City of Coral Gables Planning and Zoning Staff Recommendation

Applicant:	4225 Properties, LLC and 4311 Ponce de Leon, LLC
Applications:	Mixed Use Site Plan Review
Property:	4225 and 4311 Ponce de Leon Boulevard (4311 Ponce)
Public Hearing - Dates/Times/ Location:	Planning and Zoning Board, October 8, 2014, 6:00 – 9:00 p.m., City Commission Chambers, City Hall, 405 Biltmore Way, Coral Gables, Florida, 33134

Mixed use site plan review for the mixed use project referred to as “4311 Ponce”, as follows:

Landscape Plan

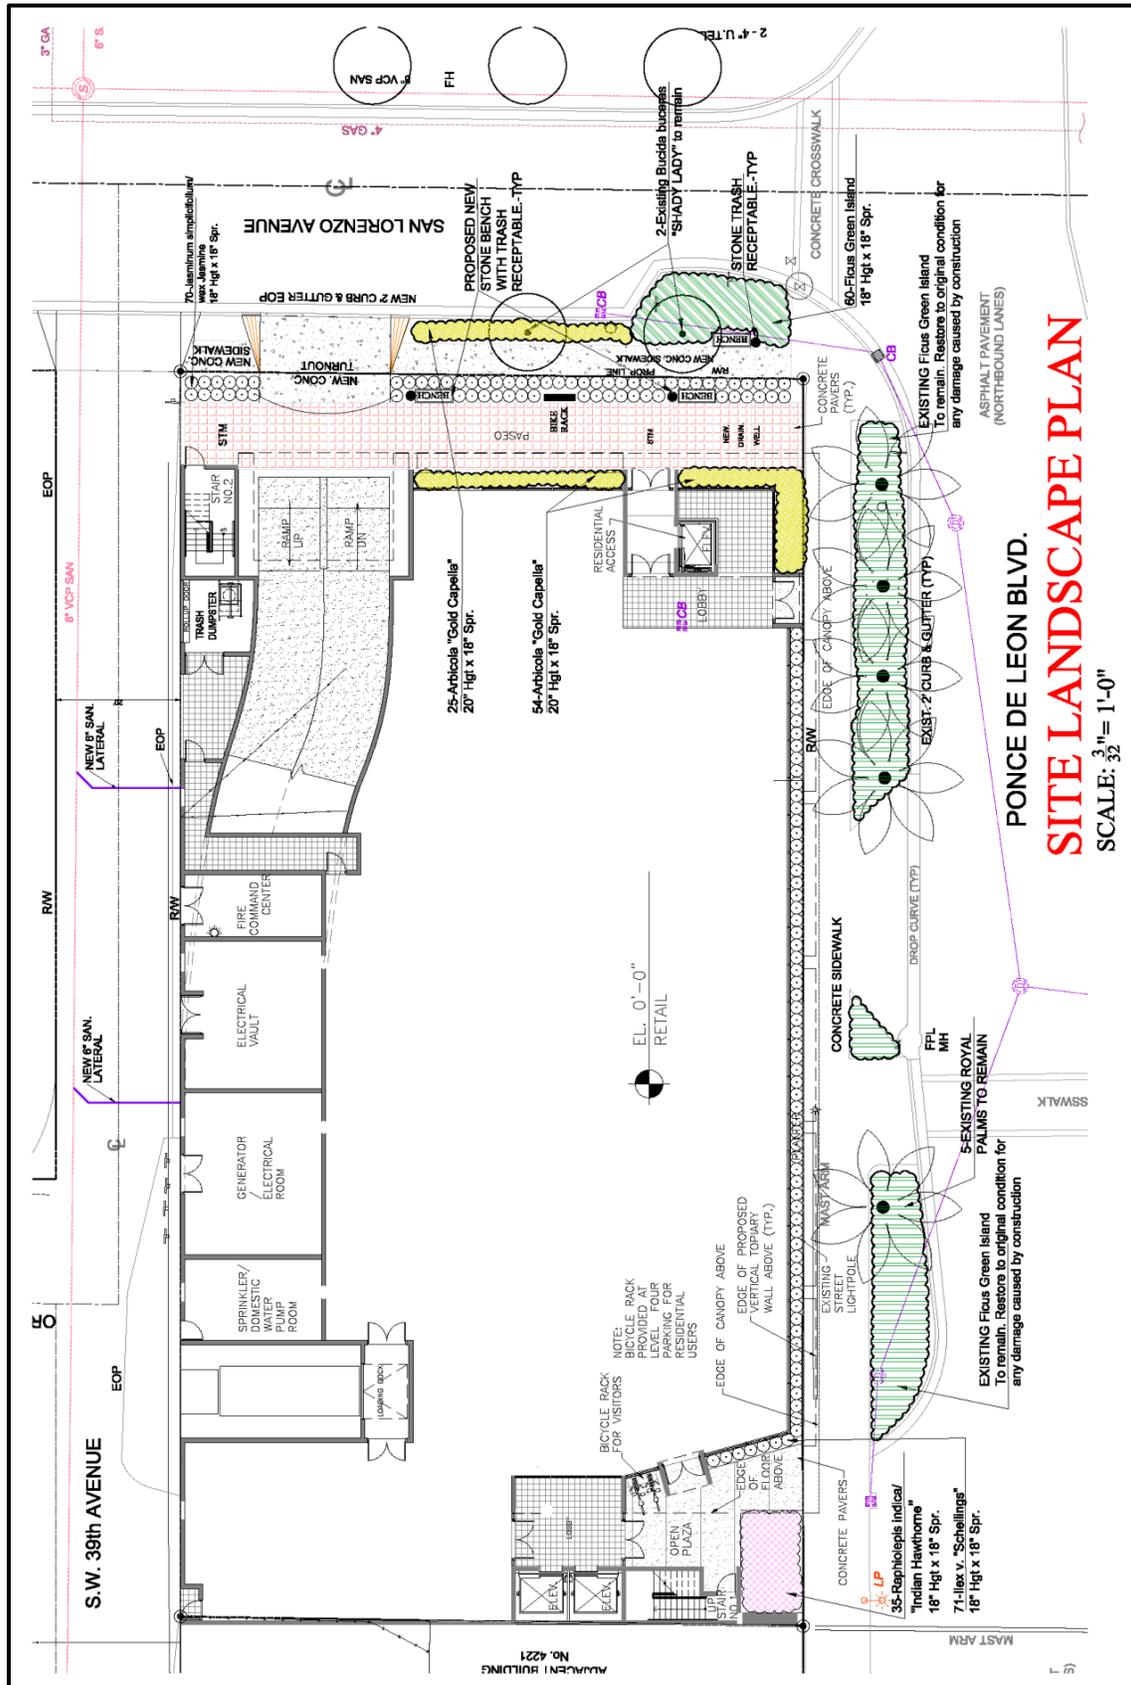
1. Since the existing driveway is being removed, the existing curb cut and driveway apron needs to be removed, replaced with a vertical curb, and landscaped with irrigation to match the existing streetscape.
2. Planting bulb outs may be required at the alleyway and parking garage entrance on San Lorenzo Ave.
3. Some form of landscape needs to be incorporated on the street level in the alleyway. i.e. Creeping Fig growing on the walls, trellis structures with vines, etc.
4. Are the overhead wires in the alley way being relocated underground?
5. The balconies on levels five and six, particularly the east facing ones, need to have planters and irrigation incorporated into them since they face the blank wall of the adjacent building.

West (Ponce de Leon Boulevard) Building Elevation

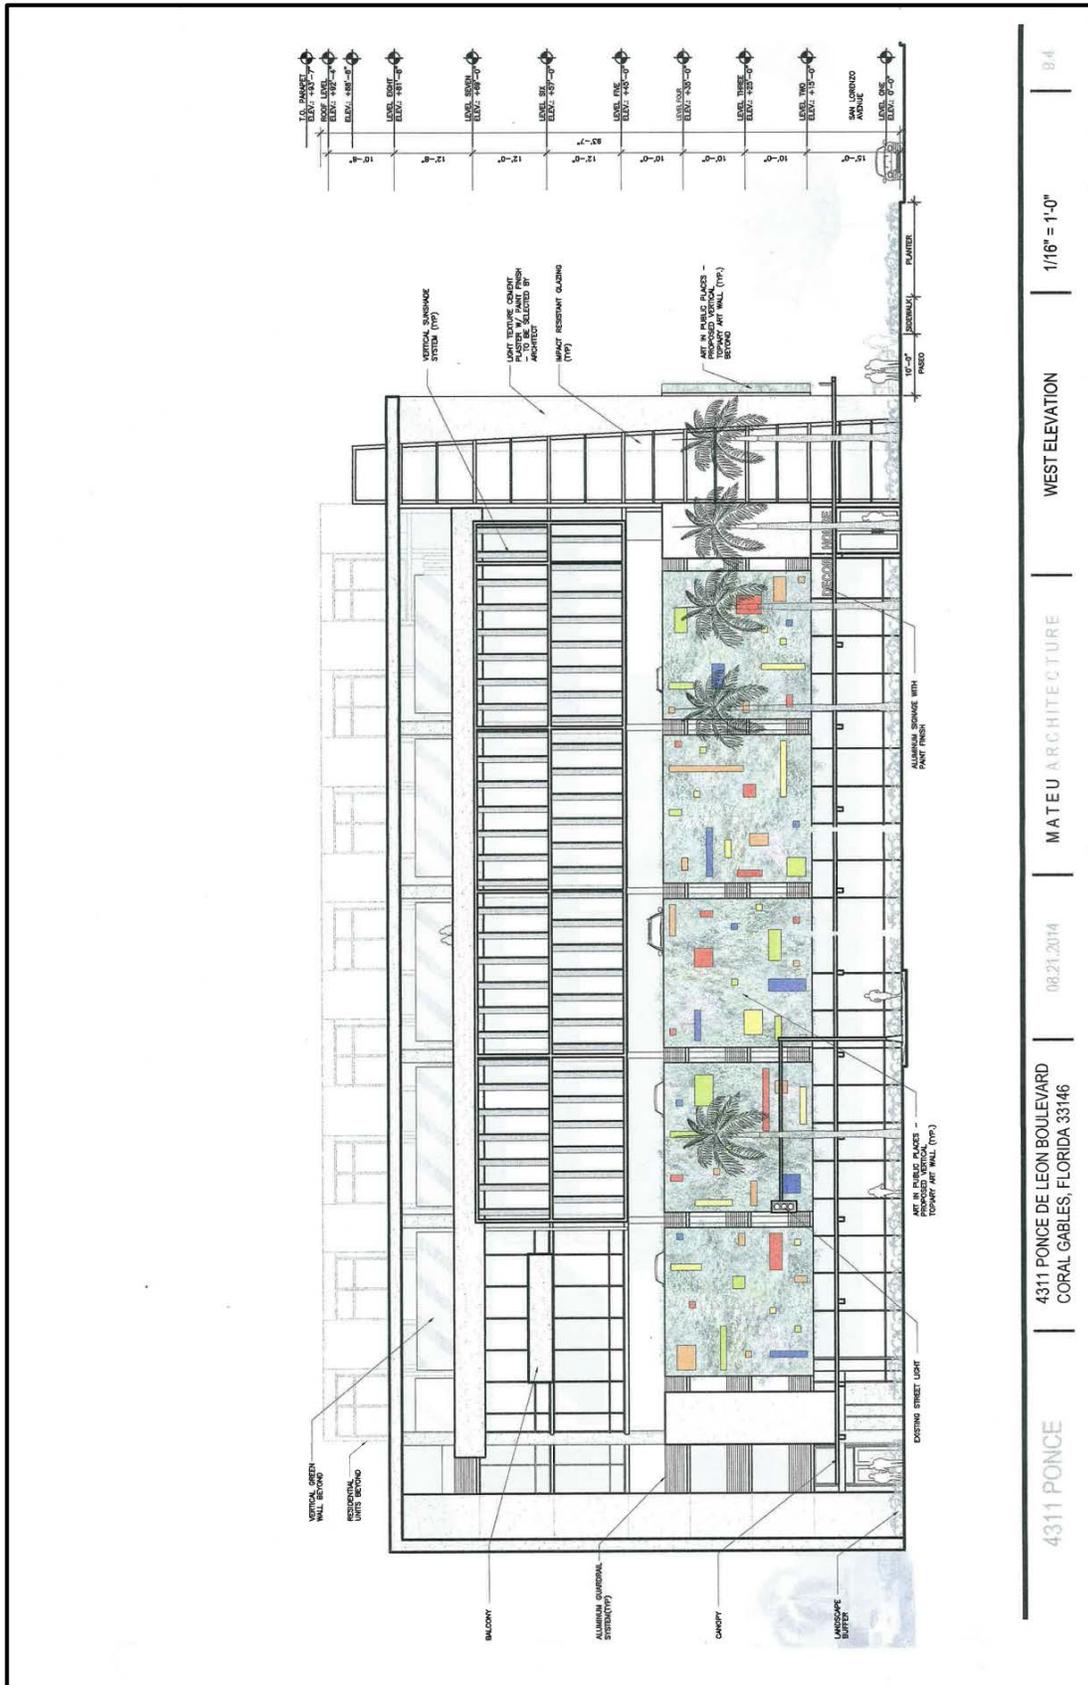
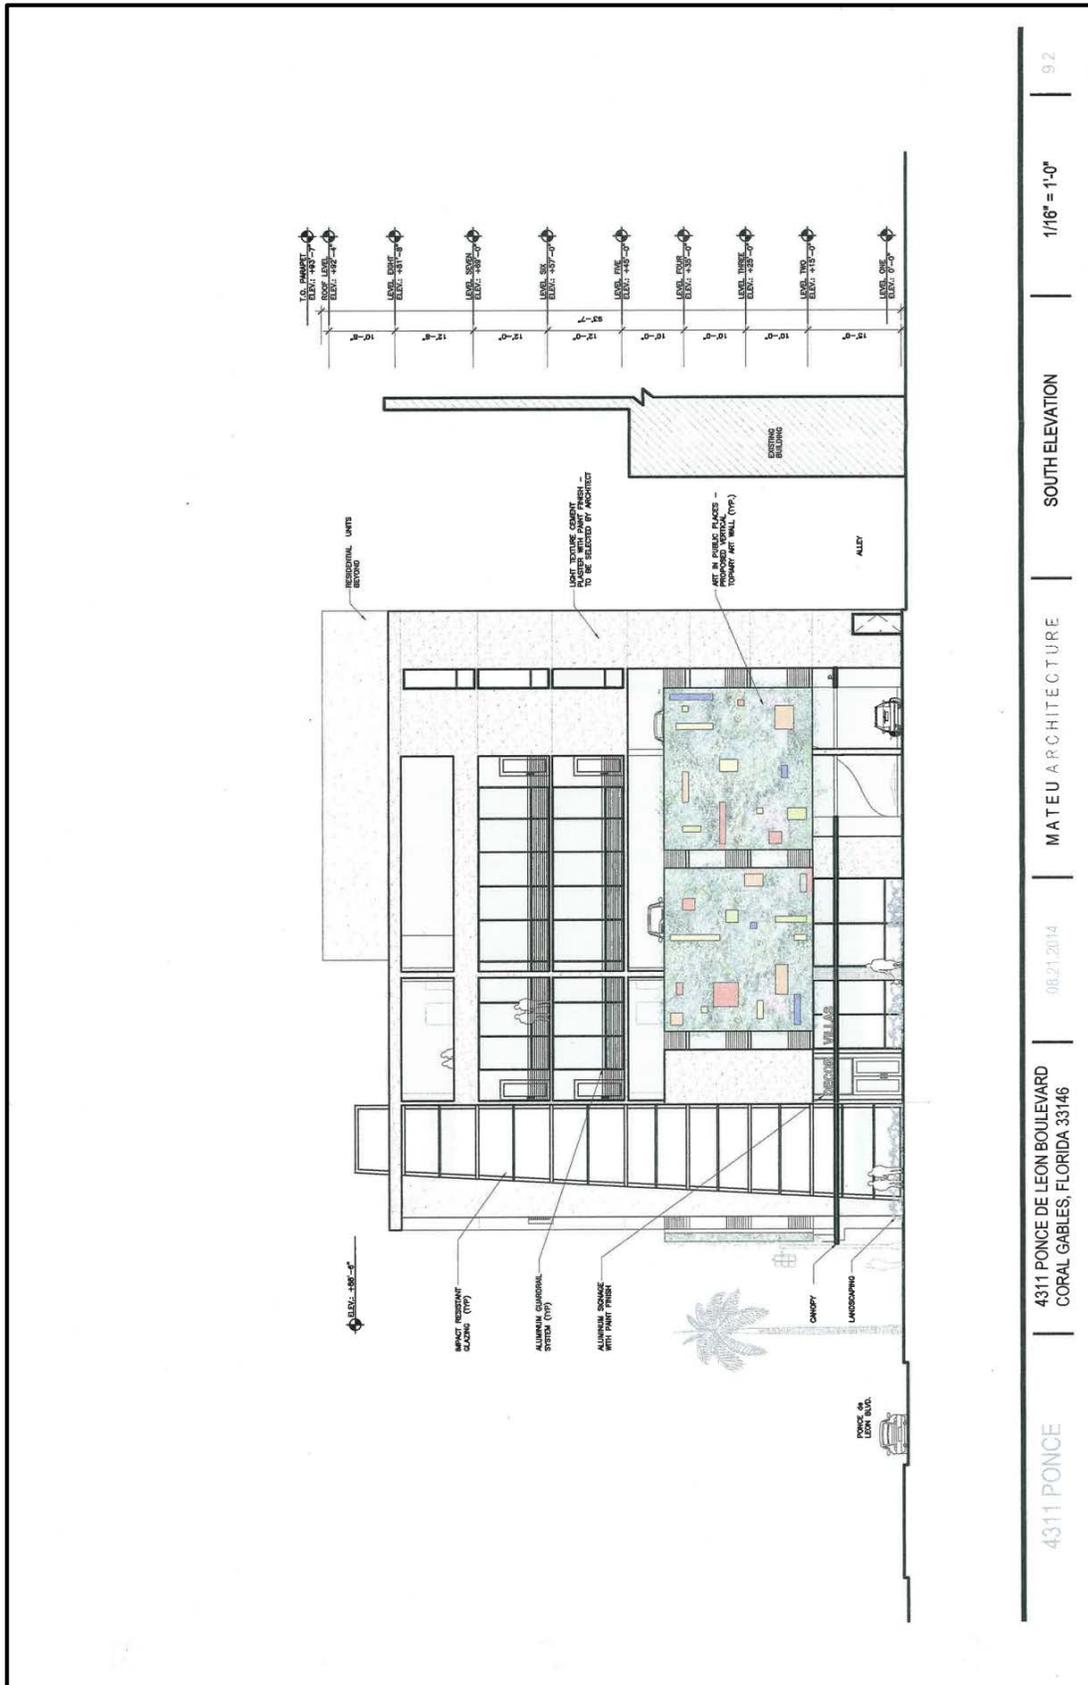
The proposed Application does not comply with the Zoning Code requirements for building setbacks/stepbacks. The Application must comply with one (1) of the following in order to meet the requirements of the Zoning Code for setbacks/stepbacks for mixed use projects:

1. Provide the minimum ten (10) foot front setback for the entire building along the front property line (Ponce de Leon Blvd). A minimum front setback of ten (10) feet is required for buildings over forty-five (45) feet in height.

2. Comply with Zoning Code Section 4-201.E.15 for setback reductions. Applicant may provide zero (0) foot setbacks on all sides if vertical building setbacks of a minimum of ten (10) feet are provided at a maximum height of forty-five (45) feet on all building facades.

Currently, the project proposes a zero (0) foot front setback with a height of 93'-7". The minimum ten (10) feet setback at a maximum height of forty-five (45) feet on all building facades has not been provided.

Type	Required*	Proposed
Front (Ponce de Leon Boulevard)	0'-0" up to 45' and 10"-0' over 45'	Complies for habitable space only
Side street (San Lorenzo Avenue)	0'-0" up to 45' and 10"-0' over 45'	None – does not comply
Interior side (north)	0'-0" up to 45' and 10"-0' over 45'	None – does not comply
Rear (SW 39 th Avenue)	0'-0" up to 45' and 10"-0' over 45'	None – does not comply
